RECAPP Facility Evaluation Report

William D. Cuts School

B4087A

Evaluation Company: Holland Roth Architects
Evaluation Date: September 13 2005
Evaluator Name: Mr. David Roth

B1010.06 Ramps: Exterior**

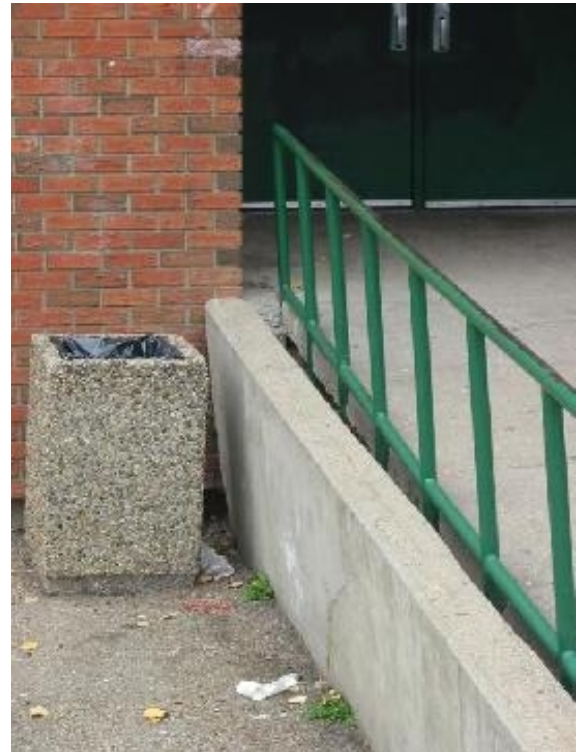
Event: Retaining wall at East loading door has failed causing ramp to settle. Guardrail has rusted, been repaired and now is too low.

Settlement/movement will continue to deteriorate ramp and retaining wall.

Replace wall, ramp and guardrail
